Karuah East Quarry Project Disturbance Area Modification (MP 09_0175 MOD 1)

Environmental Assessment Report Section 75W of the *Environmental Planning and Assessment Act 1979*

Figure 3: Threatened flora species study area and findings

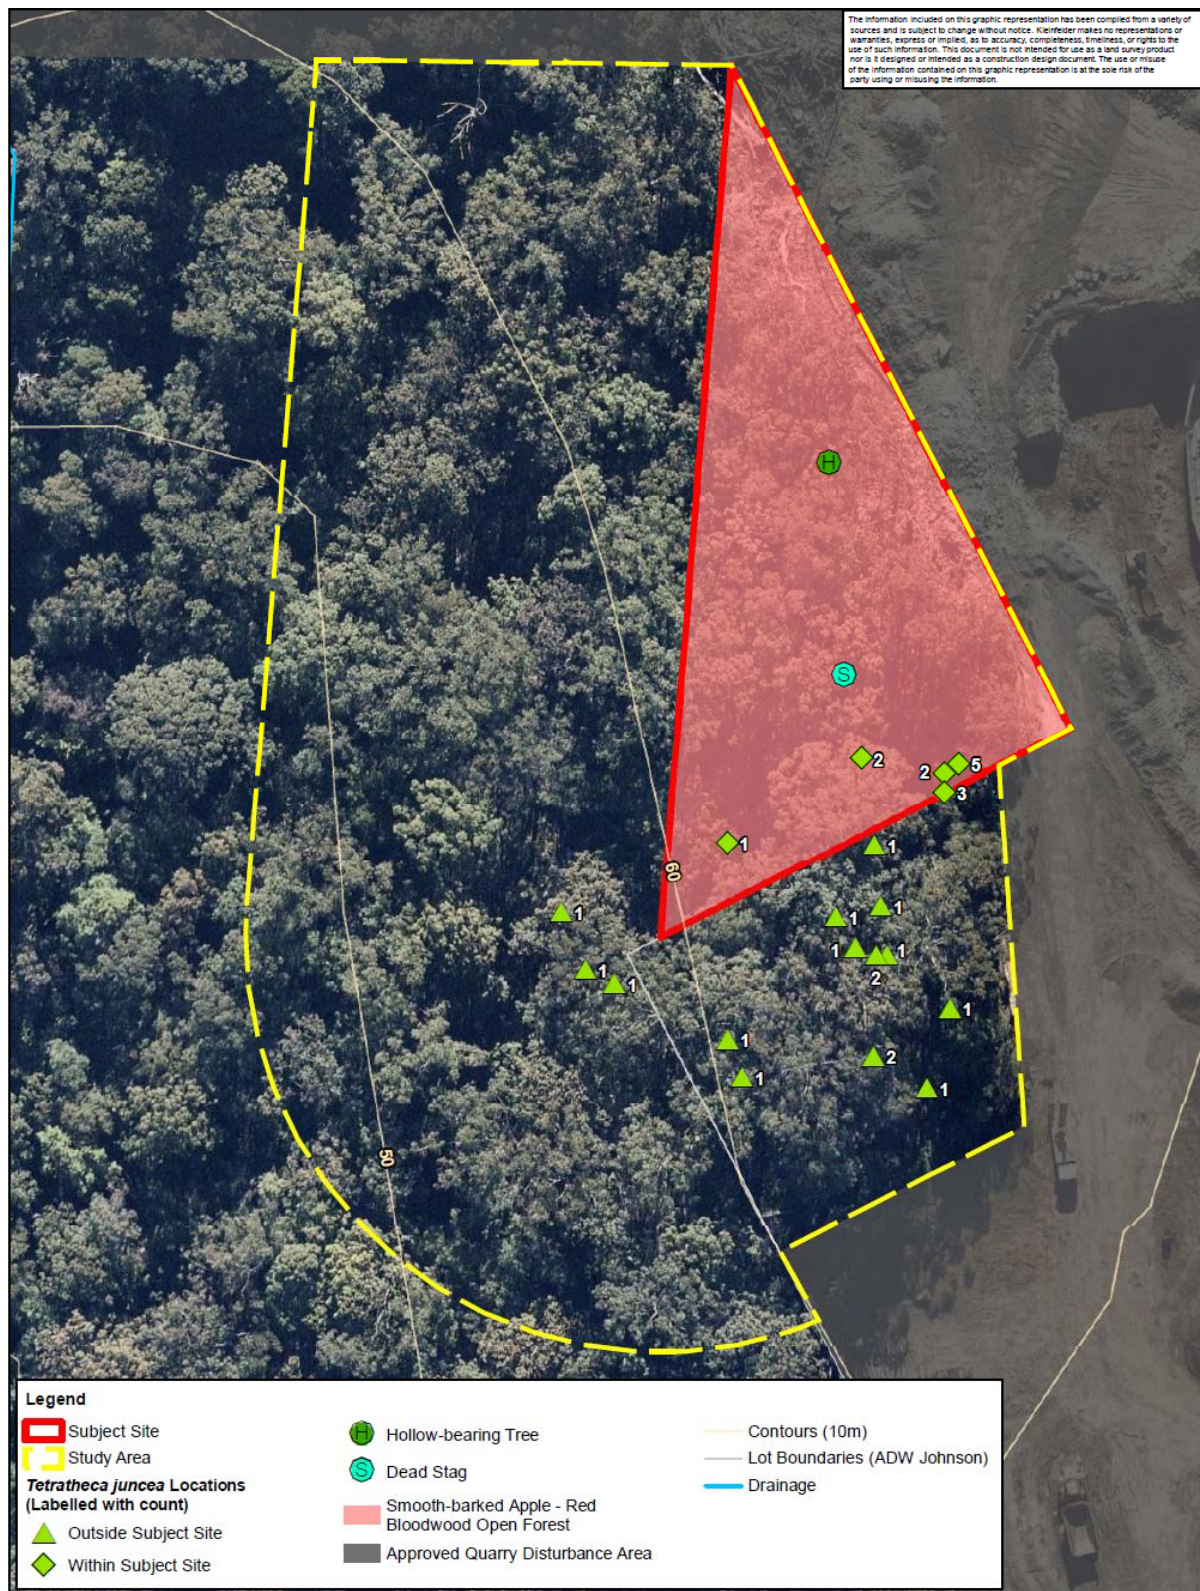
The FFIA included a targeted survey of threatened flora species within the study area as shown in **Figure 3**. Field surveys were conducted on 26 July, 11 September and 10 October 2017.

Within the disturbance area, 13 *Tetradlea juncea* (Black-eyed Susan) individuals were also observed and a further 16 individuals were observed elsewhere in the area that could be indirectly impacted by the proposal (see **Figure 3**). This species is listed as Vulnerable under both the BC Act and the EPBC Act.

The FFIA included an assessment of significance for Black-eyed Susan. Given the relatively small area of disturbance proposed, and the presence of a larger population within the adjacent Biodiversity Offset

Area, the assessment concluded that the proposal is unlikely to have a significant impact on the local population.

Figure 4: Approved Biodiversity Offset Area

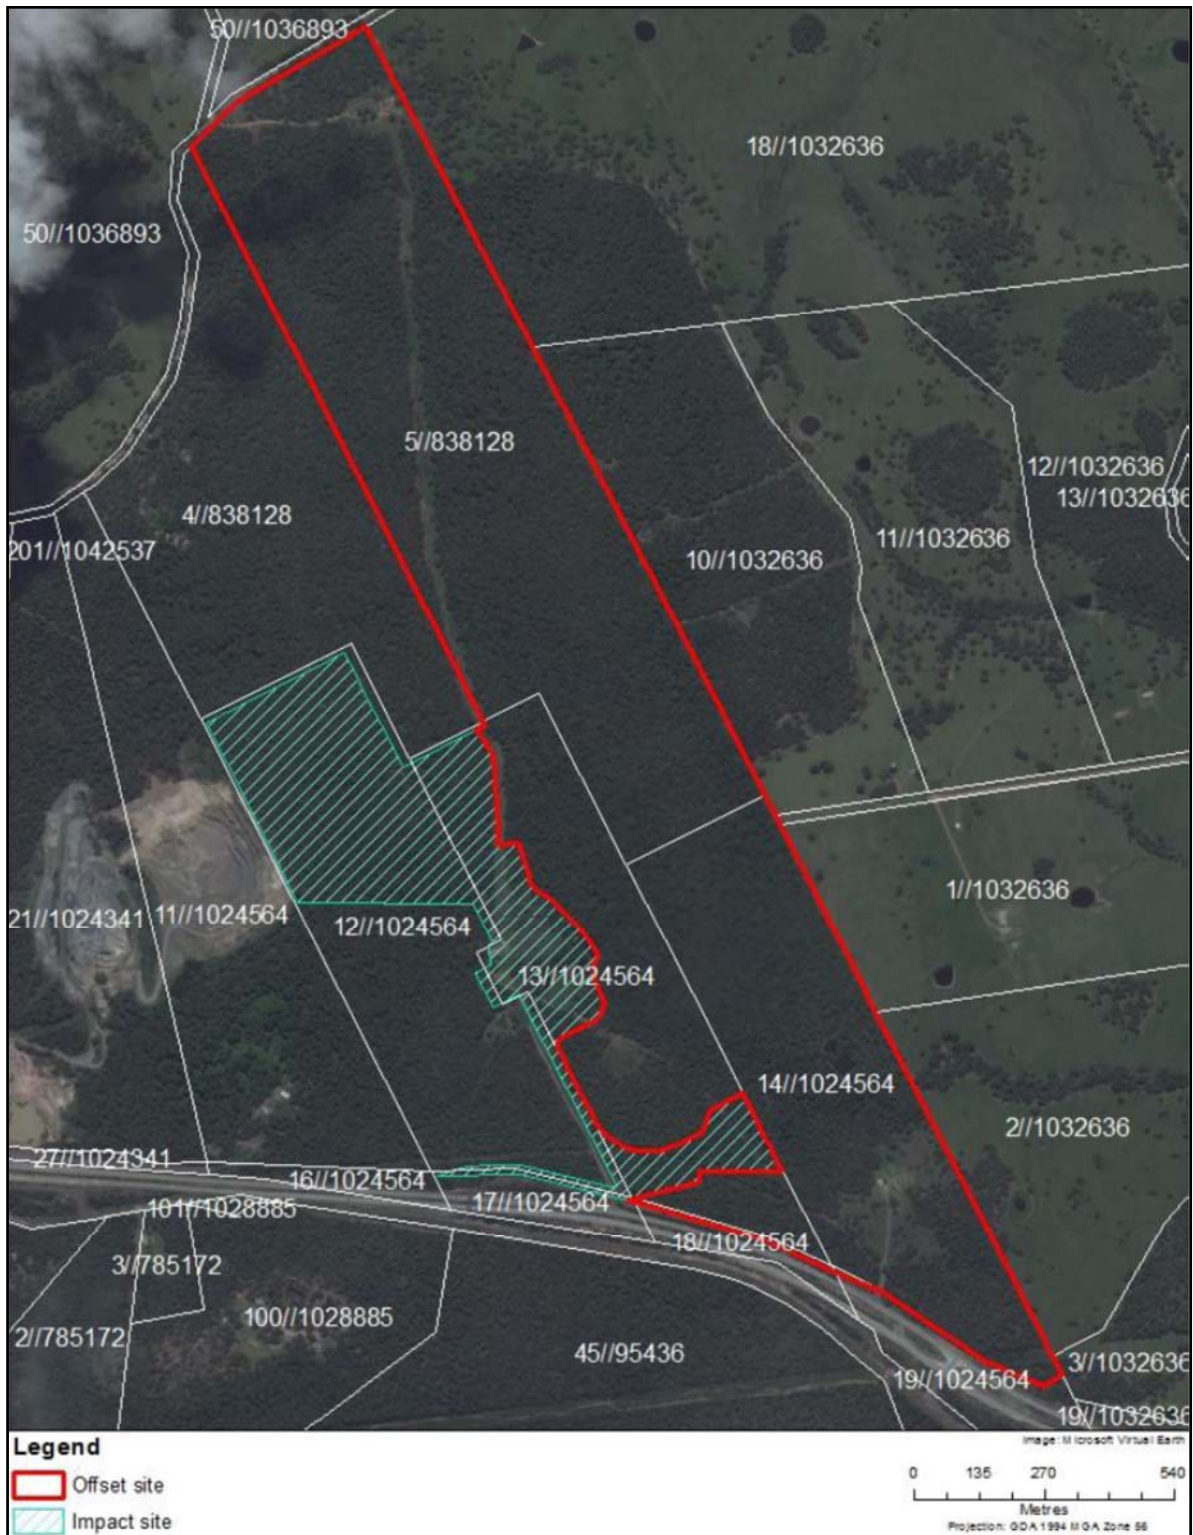
Existing conditions require KEQ to establish the offset area shown in **Figure 4**, and to make appropriate arrangements for its long-term security. Following the initial project approval, KEQ commissioned a survey of the offset area. The survey determined the actual area of the offset to be 138.22 ha (including 131.44 ha of native vegetation).

KEQ submits that the existing offset is sufficient to offset the impacts of the proposed modification, on the basis that it exceeds the requirements of the current project approval and EPBC approval, and that it generates a surplus of species credits under BBAM.

The modified project would involve the removal of 28.43 ha of vegetation. Based on the original ratio of 4.6:1, an offset of 130.36 ha would be required. As the existing offset area contains 131.44 ha of native vegetation, no further offsets would be required.

The Department recommends including the revised vegetation offset area calculation in condition 28 of Schedule 3 increasing the minimum offset area from 129.32 ha to 130.36 ha.
